RC#1

Comment: The authors present an interesting article improving water management options in the global hydrological model Xanthos where these novel options for global hydrological models forsee irrigation, hydropower and flood control reservoirs. The spatial resolution is 0.5 °. Different operation rules were applied to the different reservoir type after optimizing long-term hydropower production. Model results were compared to measured streamflow data and the agreement was improved for most basins. The paper can be published after minor revisions:

Change in the manuscript: Updated Figure 5

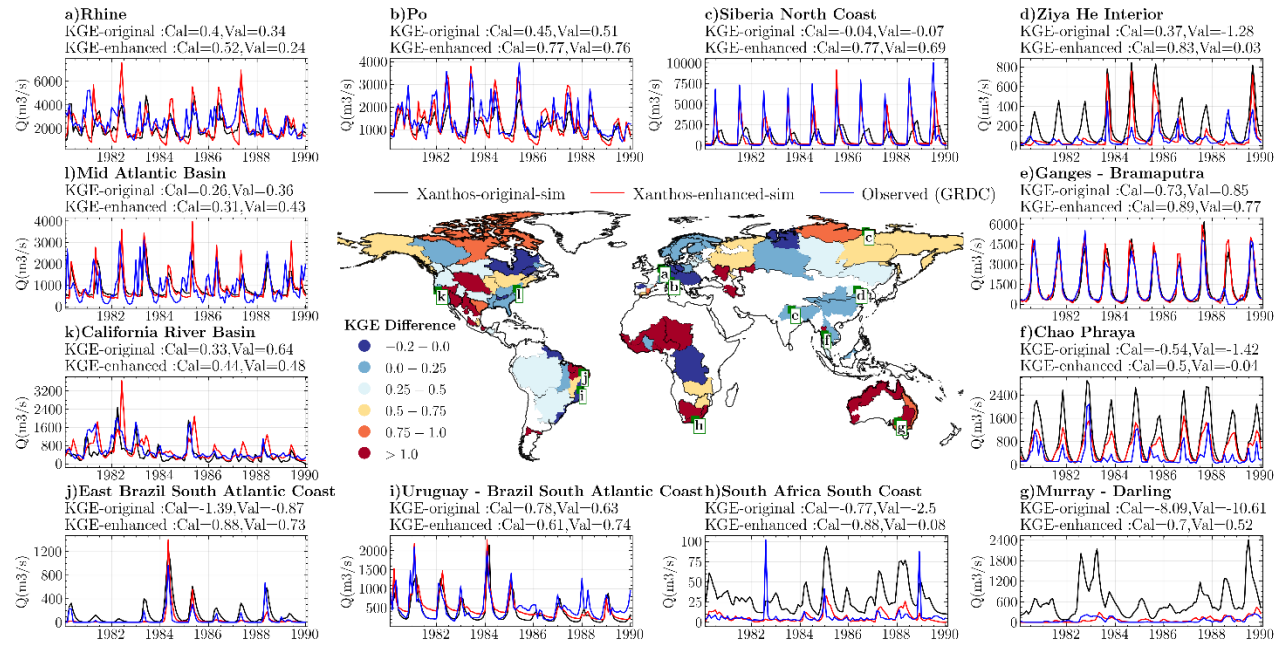
- Several times you mention several basins (e.g. l. 445f) or rivers (Fig 5); it would be interesting to see were they are located in the world; try to include that in the figures:

Response: Thank you for your suggestion. We appreciate the importance of providing clear geographical context for our study. To this end, the locations of all 91 basins referenced in this study are presented in Fig. 3c; in addition, we included labeled basins in the supplementary material as Fig. S7. Additionally, in Fig. 5, the subplots' labels (a, b, c, ...) correspond to the labels on the map. We noticed and corrected a labeling error in Figure 5 where the labels were misplaced. We trust that these modifications will clarify the geographical context of the basins and rivers involved in our study.

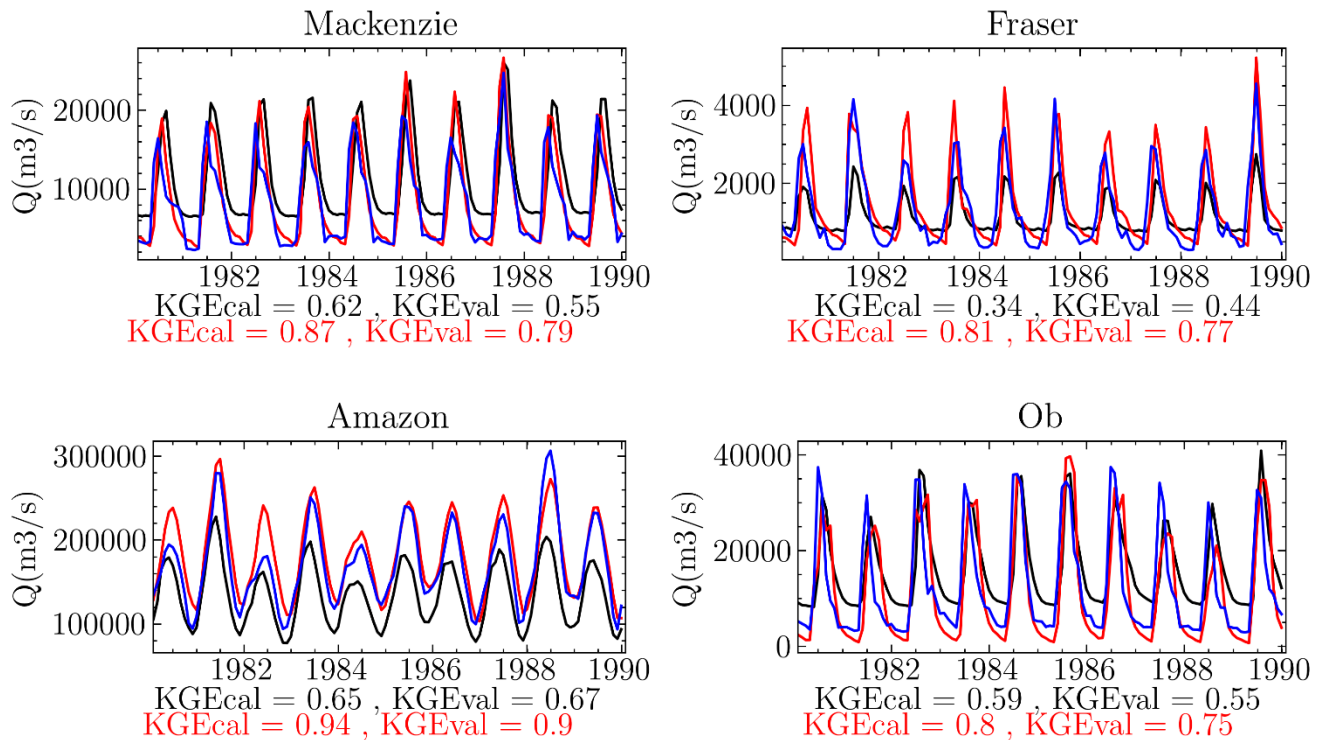
Comment: L447-448- is the improvement in high and low flow periods one that has only been observed visually or have you quantified this?

Response: Thank you for your question. The improvements in high and low flow periods that we referenced were primarily based on visual observation from simulated flows across all the basins we analyzed. While we have not quantitatively measured these enhancements, the patterns were consistently apparent in our visual data assessments. Here are examples from some of the well-known river systems from different regions (black is without and red with water management , blue is observation)
